Ethan Allen Gateway Streetscape Project

Pre-Design Meeting – January 18, 2012

Ethan Allen Gateway Streetscape: January 18 Meeting Comments

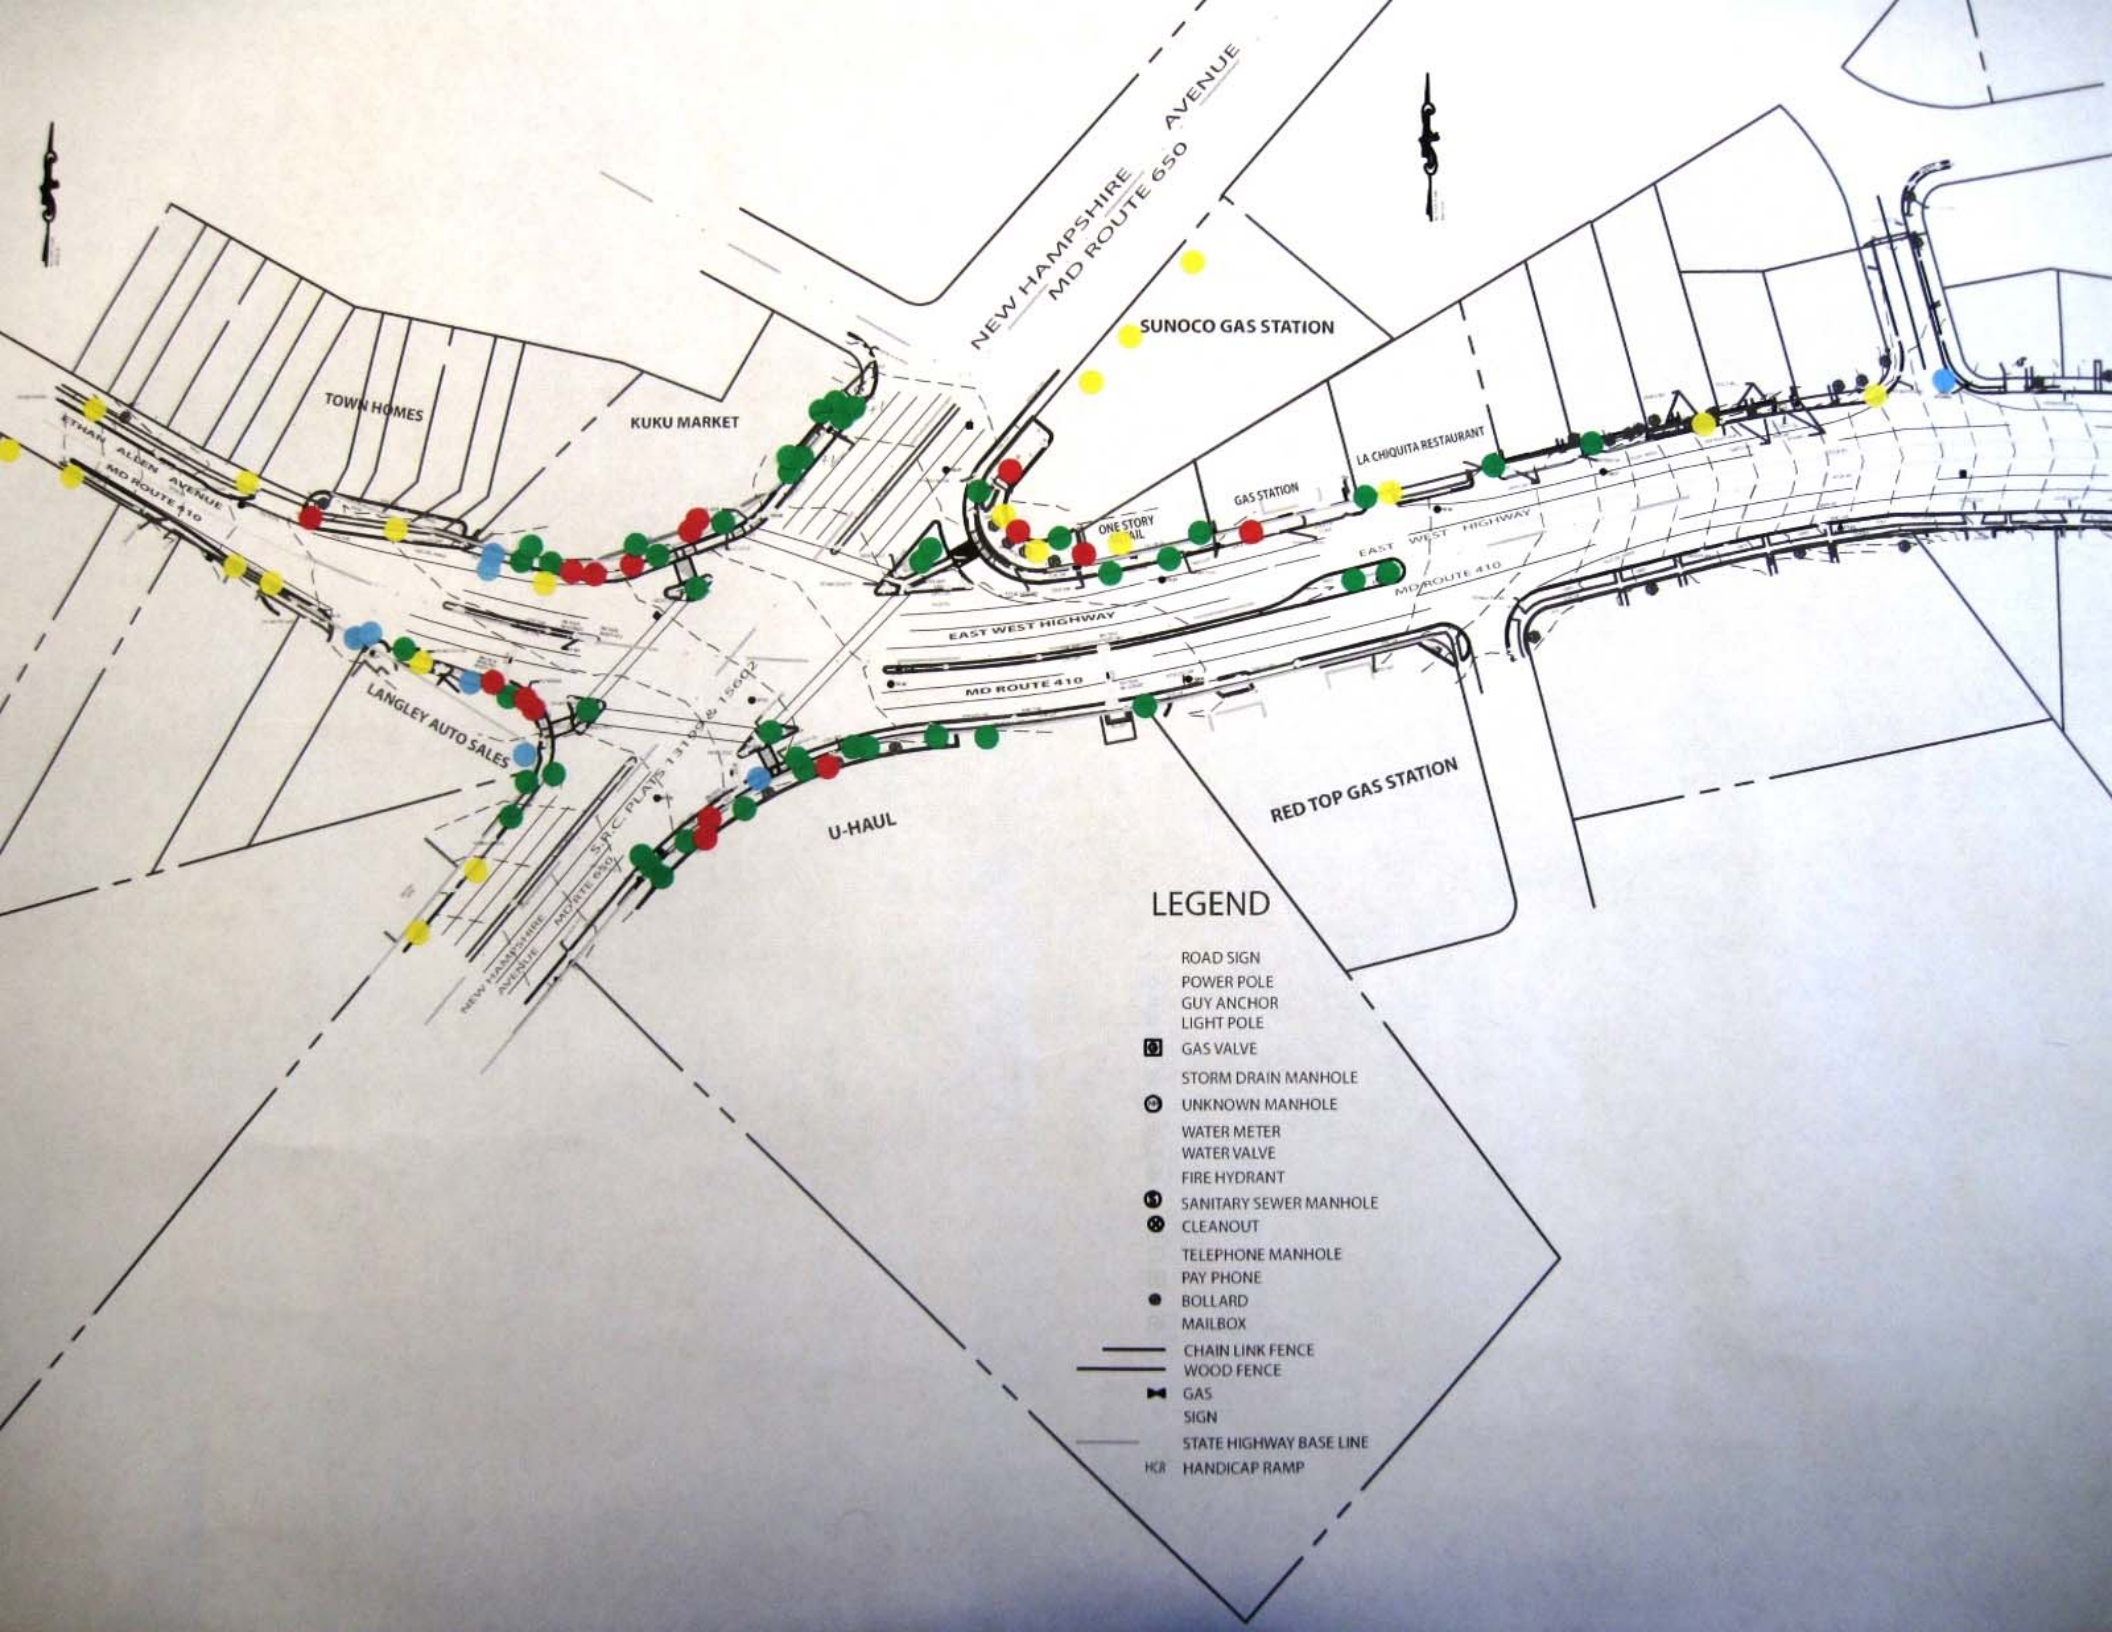
- Pedestrian safety crossing NH and Ethan Allen
- Raised crosswalks, High visibility crosswalks
- Reconfigure westbound 410 @NH Avenue: Allow one lane to cross, one left turn, and one right turn. Narrow west side to one westbound lane. To avoid “the race” from two lanes to one.
 - o A redesigned right-turn could also address the pedestrian crossing. The pedestrian crossing should be protected with a light and signal.
- New pedestrian crosswalks and island: incorporate into plan – don’t waste \$\$ already spent!
- The intersection is too big, a massive concrete field! Will it be possible to increase the “pedestrian curb” (don’t know what to call it) where there is a small triangle of curb at the edge of the intersections so that the effect is to decrease the overall surface area of this massive intersection? You could put trees on them, whatever...

- Scary pedestrian crossing, cars zip through lane. No pedestrian signal to get to island with signal
- Pedestrians have to wait a long time to cross with walk signals, especially if crossing from Shoppers to Kuku Market corner

- This is a scary crossing with very low visibility for cars / pedestrians

- Cars cut through traffic thru parking lot of Kuku Market from NH southbound to Ethan Allen westbound
- 5-7 minute wait to cross and then have to run.
- No right on red (N to New Hampshire) for pedestrian safety

- There is a sidewalk gap in this area somewhere (*adjacent Glazwood Manor townhomes*)
- Sidewalk no continuous (*adjacent Glazwood Manor townhomes*)
- Need continuous sidewalk, preferably with buffer from road (*La Chiquita*)
- Needs sidewalk (*East of La Chiquita*)
- Sidewalks on East West, north side (*La Chiquita and east*)
- Need sidewalk connection to existing PG sidewalk on north side (*Takoma Park – Prince George’s boundary*)
- More sidewalks on MD410 and wider for pedestrian safety

- Low Impact Design stormwater management street tree boxes
- Please examine the options for catchment and filtration of stormwater (in the gutters) before it enters the stormwater drainage system if possible.
- Please make a serious effort to decrease use of impervious pavement wherever possible.
- Smashed-in gutter (*median in Ethan Allen Avenue near New Hampshire Avenue intersection*)

- Native trees labeled for education purposes
- Whole intersection is devoid of trees or any plants except near Sunoco. Need trees near bus stops.
- Please put them in as many places as you can! I can't put a dot everywhere there should be a tree. And use as many of these enhanced water catchment systems as possible.
- Silva cells with Oak Trees (willow oak) on each pedestrian island
- More plantings and trees throughout the intersection
- Trees for shade at bus stop (*southbound, at North corner of intersection*), do double duty with stormwater management

- People cross middle of block because of bus stops (*across E-W Hwy, at Red Top Road intersection*)
- Safe cross needed to access East-bound busses (*across E-W Hwy, at Kentland Avenue intersection*)
- Improve safety, visibility, and aesthetics of southbound bus stops on New Hampshire Avenue

- Large sign to indicate Takoma Park, the distances are large and tiny signs elsewhere in the city won't suffice here.
- "Ethan Allen Ave" Sign
- Please add prominent signs that indicate "Ethan Allen Ave" on New Hampshire Ave in both directions
- "Welcome to Takoma Park" sign here (*at north corner of intersection, Kuku Market*)

- Wherever you put in lighting, please don't make it brighter than necessary – consider dark sky needs!
- Lighted crosswalks!

- Road grading at this right turn inevitably causes spin-out even on dry road (*from Kentland onto E-W Hwy westbound*)
- Kentland Avenue and E-W Hwy: no crosswalk but students from Don Bosco High School cross to get bus

- At either U-Haul or Kuku Market, create a food truck serving zone for multiple trucks. While the trucks would park on private land, the pedestrian access to the windows would be from the extra wide streetscape sidewalk. Similar to the Falafel Truck.
- Rats! Lots of rats (*in landscaped area at East corner of intersection*)
